MEETING: REGULAR MEETING OF THE PLAN COMMISSION
DATE & TIME: Monday, June 9, 2025 at 6:30 PM
LOCATION: Germantown Village Hall Board Room
N112 W17001 Mequon Road

- V. **UNFINISHED BUSINESS:**
 - A. Parish Survey & Engineering, Agent for Matt Seban and TLC Acres, Property Owner W210N10738 Appleton Avenue. Site Plan Review for a 5,200 sqft building and a Conditional Use Permit (CUP) Application to allow grading & filling within a 25' wetland and 75' navigable waterway setback. (ACTION; Continued from April 28)

- VI. **NEW BUSINESS:**
 - A. Ken Frank, Agent for Home Path Financial, LP, and Mohrhussen Family Farm, LLC, Property Owner. Rezoning application to create the "Sutton Farm" Planned Development District (PDD) and Rezone 88.3 acres from the A-1: Agricultural District into the Sutton Farm PDD; and a Preliminary Subdivision Plat for an 88.3-acre residential neighborhood comprised of 171 single-family units and 102 multi-family units located at the northeast corner of Lannon Road (CTH Y) @ County Line Road (CTH Q) in the Lannon Gateway Neighborhood. (PUBLIC HEARING & ACTION)

C2.05

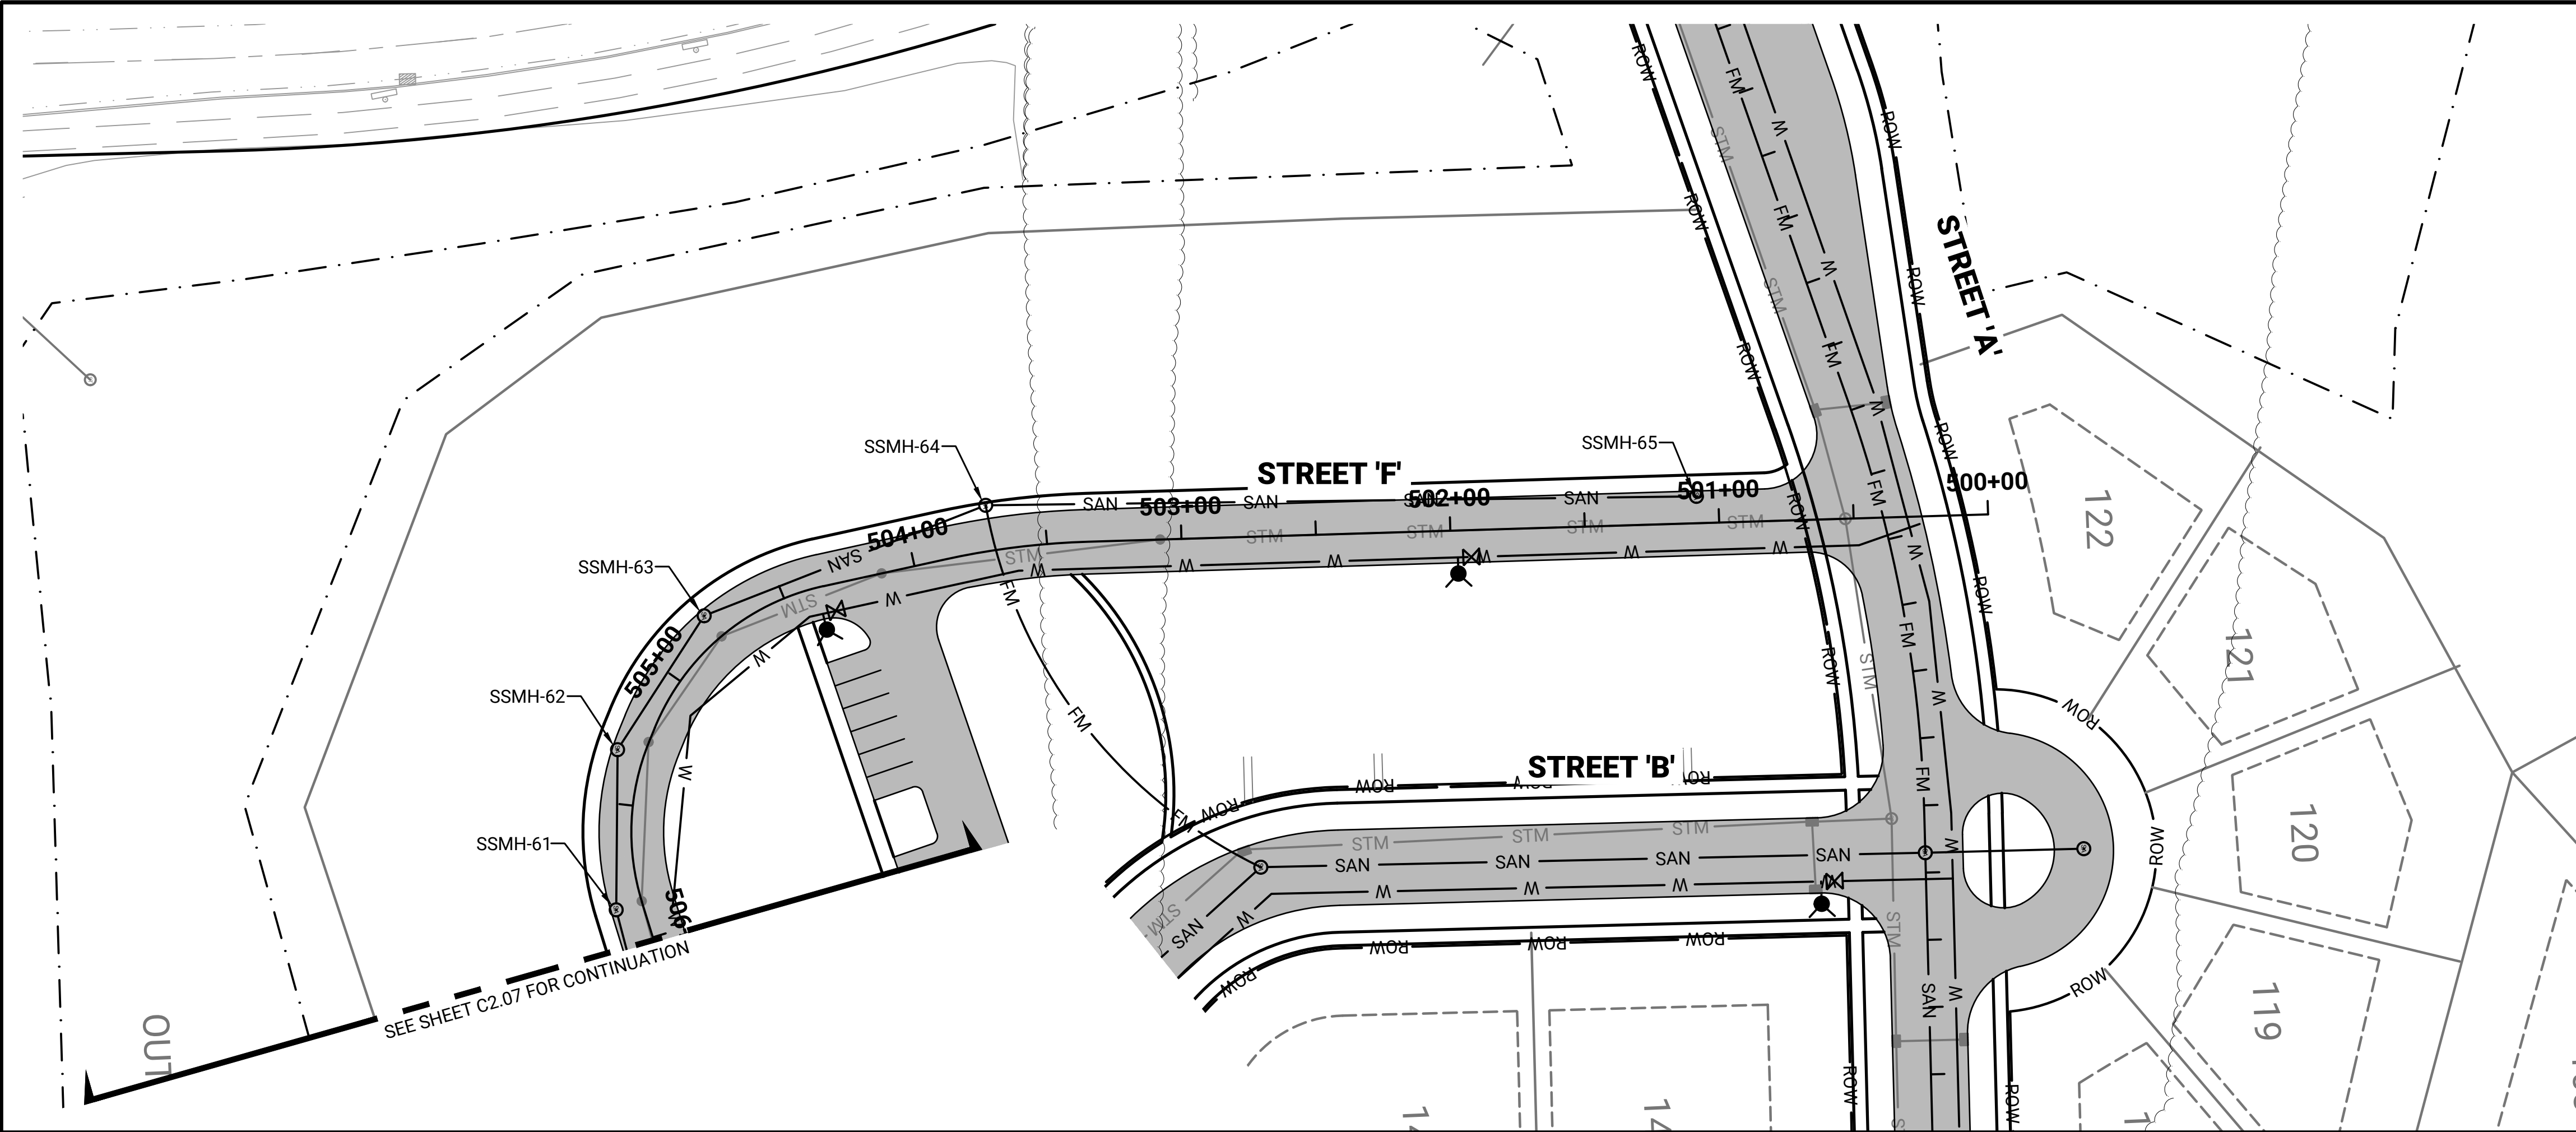
- C2.04 – Show vertical clearance in profile between sanitary and water near Street L and Street E.
- C2.05 – 5ft of cover is not accepted per the Development Handbook: 3.1.1.2.9 Minimum sewer depth shall be 8 feet from finished grade to top of pipe, except under exceptional circumstances and approval of Village Engineer. Sewer depths shall provide gravity flow for basement floor drains and plumbing fixtures.
